# SERVICE LETTER

No. 718

Subject: Bendix Magneto Bulletin No. 566 -- reference attached Avco Lycoming Service Bulletin No. 373, dated March 22, 1974.

**SUBJECT:** S-1200 Distributor Block and Gear Change

Figure 1.

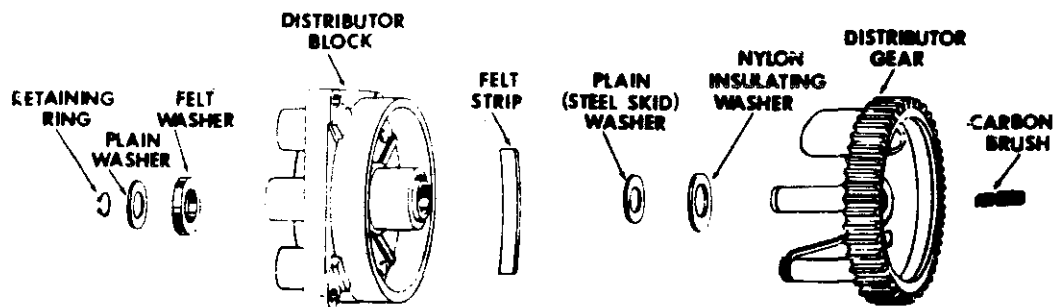
**Detailed Instructions:**  
It has been found that the addition of a nylon insulating washer and steel skid washer between the distributor gear electrode and the block bushing, as shown in figure 1, reduces the possibility of deterioration of the lubricant and possible seizure of the parts.

Once modified, the distributor block can be used only with a gear having the nylon and steel washer installed over the shaft as shown in figure 1.

Assemble large distributor gear, nylon and steel washers to new or reworked block as follows using figure 1 as a guide.

2. Slide nylon insulating washer 10-391309 and plain washer 10-391511 onto gear shaft.

3. Lubricate inside of bronze bushing with a light film of Bendix Distributor Block Lubricant. \*\* Insert shaft of gear through distributor block and position plain washer on shaft. Using the 11-3071 Retaining Ring Pliers, install retaining ring on shaft. Rotate gear to insure there is no interference between gear electrode and block electrodes.

Figure 2

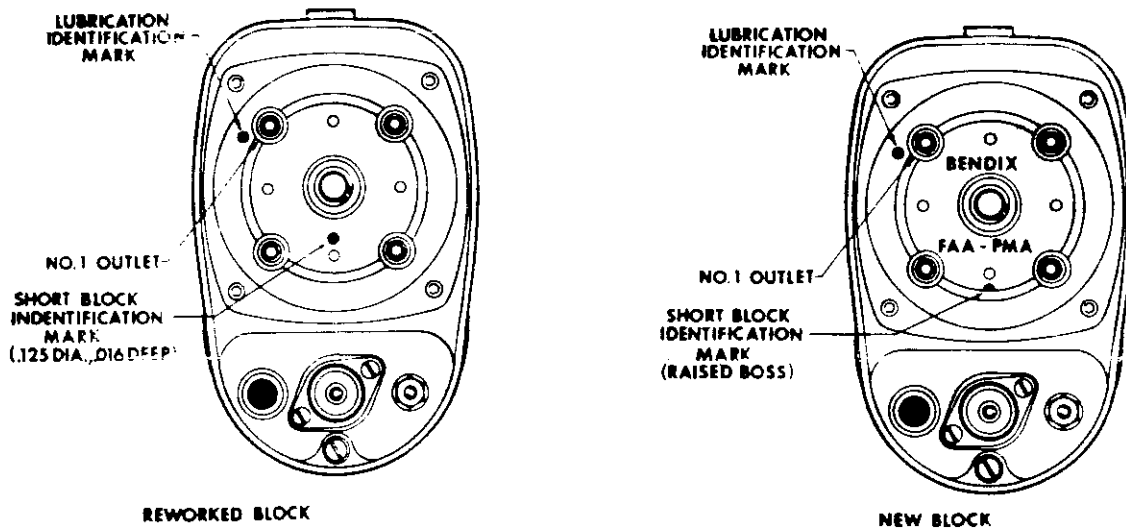
The addition of the washers make it necessary to shorten the gear end of the bushing and block. New production blocks incorporating the change are identified by a raised

boss between the high tension towers at the six o'clock position and molded in letters as shown in figure 2. Reworked blocks are identified by a drill point indentation in the same location. New and reworked blocks both have different part numbers from the current (old) block. See Table 1.

7. Identify reworked blocks by drilling a flat bottomed hole .125" diameter and .016" deep in the six o'clock position as shown in figure 2.

(3) Identify distributor block by drilling flat bottomed indentation 0.125 inch diameter and 0.016 inch deep located as shown in figure 2.

Figure 3.

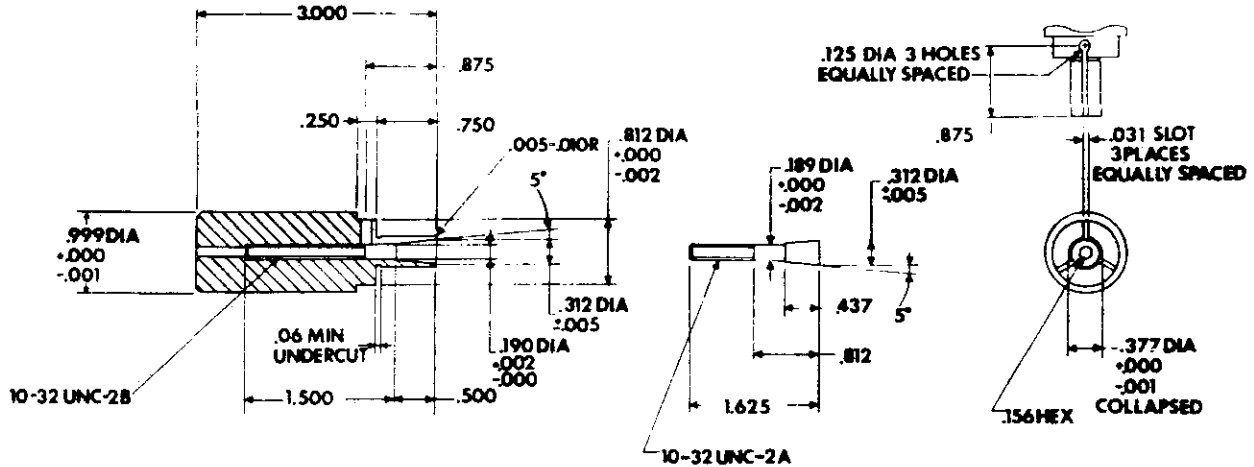
2. Fabricate an expanding arbor lathe fixture as shown in figure 3. (Similar arbors may be purchased from industry machine tool supply houses.)

Figure 4.

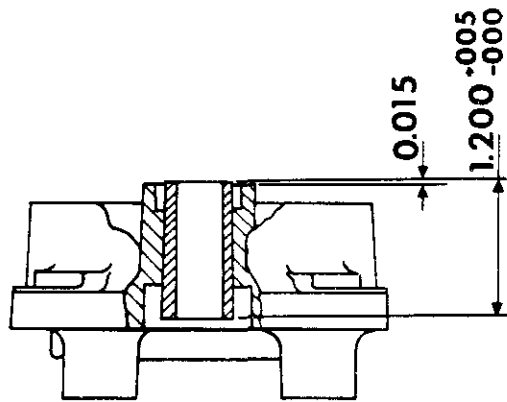
4. Use a suitable cutting tool and turn so that overall length of bushing is  $1.200 + .005 - .000$  inch as shown in figure 4. (A Carbide tipped tool is recommended.)

5. Using same cutting tool, turn dielectric material of block so that resulting surface is .015 inch below end

of reworked bushing. See figure 4.
